WARREN H. OHL DAM

INVENTORY NUMBER NDS 394

PHASE I INSPECTION REPORT

NATIONAL DAM INSPECTION PROGRAM

PLATE IV

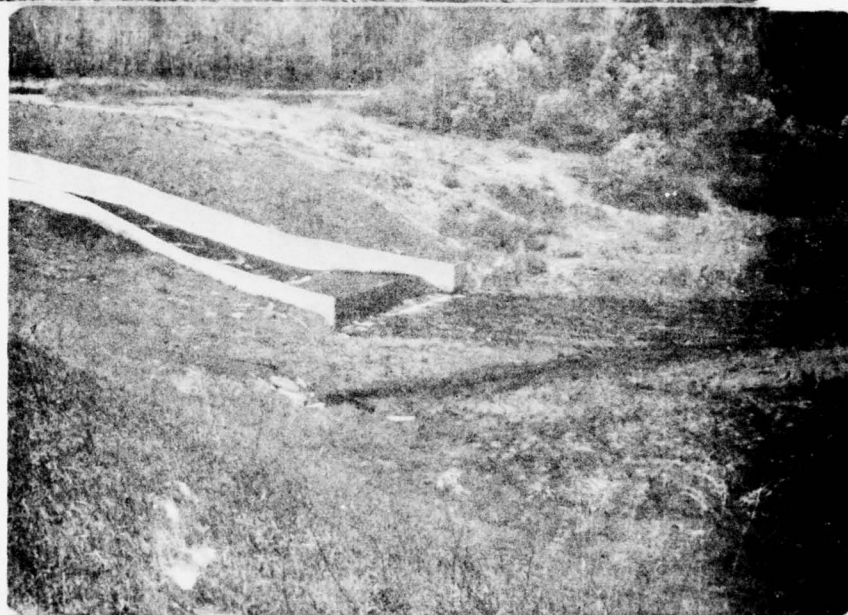
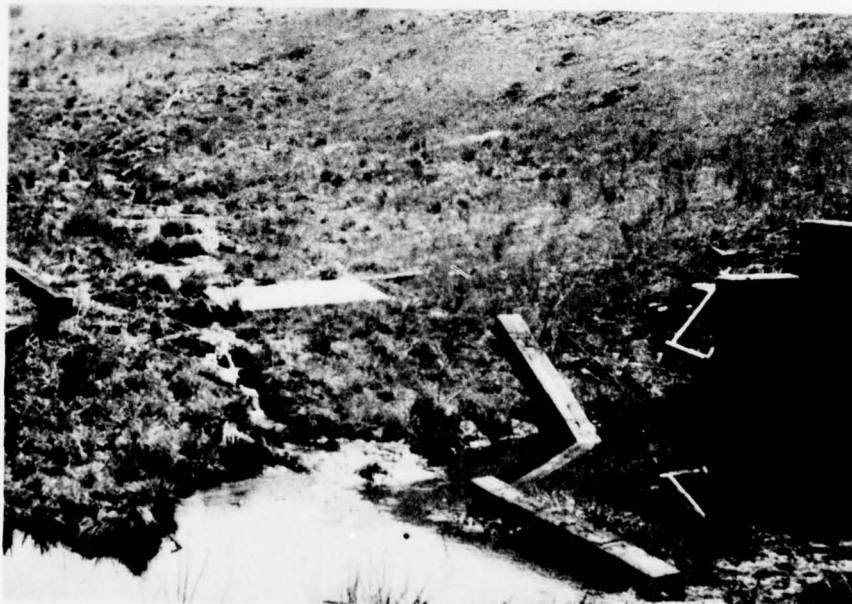
The dam embankment is maintained in fair condition. There is evidence of seepage on the slope and the toe was wet and soft in some areas. A few places on the embankment indicated mole activity. Between the embankment and the spillway is a large wet area. (See sketch in Appendix A). There was no evidence of cracking or visually detectable settlement in the embankment. Some sloughage has occurred close to the conduit. The riprap on the upstream slope and the dam crest road is in excellent condition. The drain near the downstream end of the spillway wall carried a considerable amount of water (Appendix D, Plate IV, top photograph).

Seepage close
To Spillway

Conduit
Conduit Outlet
and Right
Abutment Seepage

1. Owner should control the seepage existing on the embankment slope and along the toe.
2. Owner should investigate the cause of and provide for the control of standing surface water between the embankment and the spillway.
3. Backfill all woodchuck holes.
4. Owner should monitor and record seepage quantities. If the flow increases with time, implement remedial measures at once.

394
PLATE VII

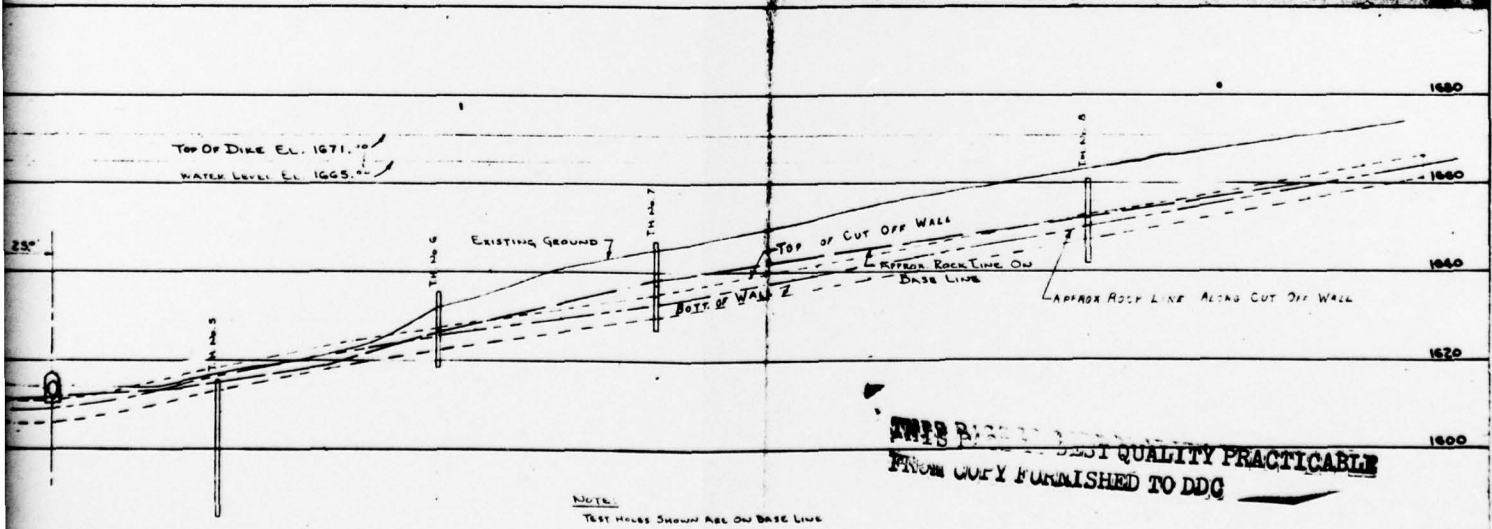
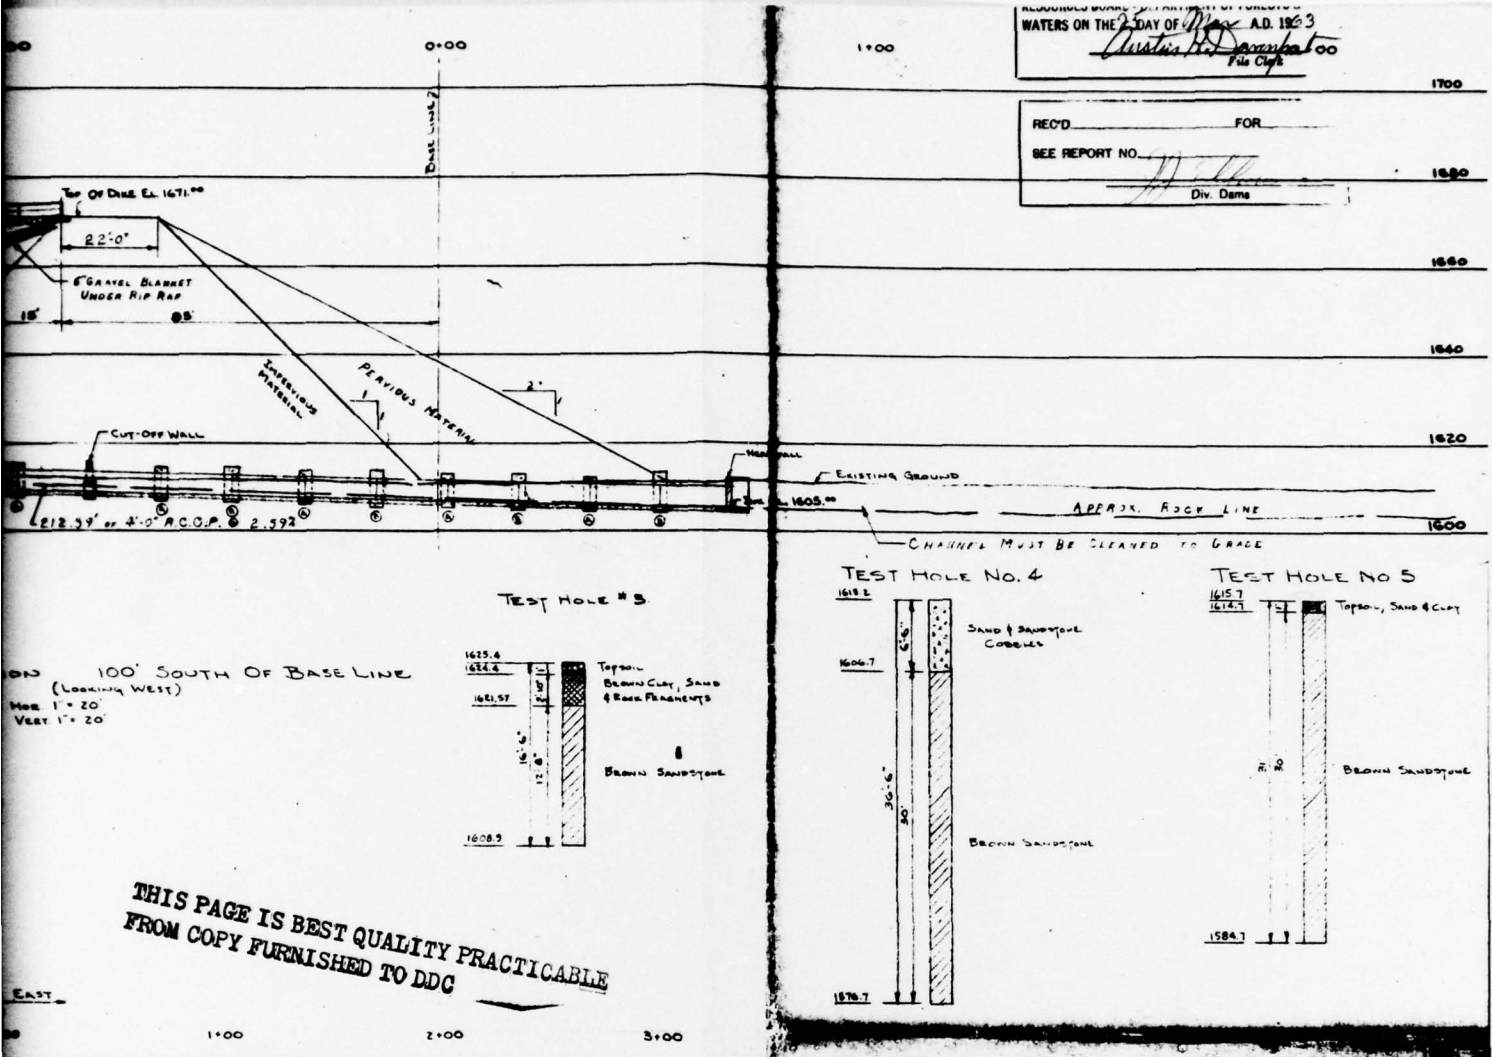
The information for the embankment consists of one typical section and a general plan. Eight core borings in the valley are on the plans (Appendix D, Plate VII). The borings are located on a line 74' downstream from center line of dam. Design criteria or stability calculations were not available.

The design drawings indicate a trench was to be excavated to the top of rock on the centerline of the dam, and a concrete cutoff wall to be constructed extending three feet into the rock, and two feet into the embankment fill. The cutoff wall, located on the centerline dam, has tapered sides above the rock surface to improve compaction of the fill. The design drawings indicate the core wall over the full length of the embankment and across the spillway. Maximum height of embankment above bottom of cutoff trench is approximately 65 feet. The impervious zone has slopes of 1H to 1V on the upstream and downstream side. The material placed outside is shown as pervious material. There are no indications of internal drains or a toe drain. The top width of the dam is 22 feet (Appendix D, Plate VII).

The intake tower is set on rock and consists of reinforced concrete walls of varying thickness. A cradle was placed under the 48" conduit in rock. Cut-off collars are shown on the conduit at intervals of approximately 15 feet. (Appendix D, Plate VII).

The embankment design, as indicated on the contract drawings, is considered to be adequate if the pervious material would be sufficiently granular. However, with the volume of seepage, construction of a toe drain is considered desirable.
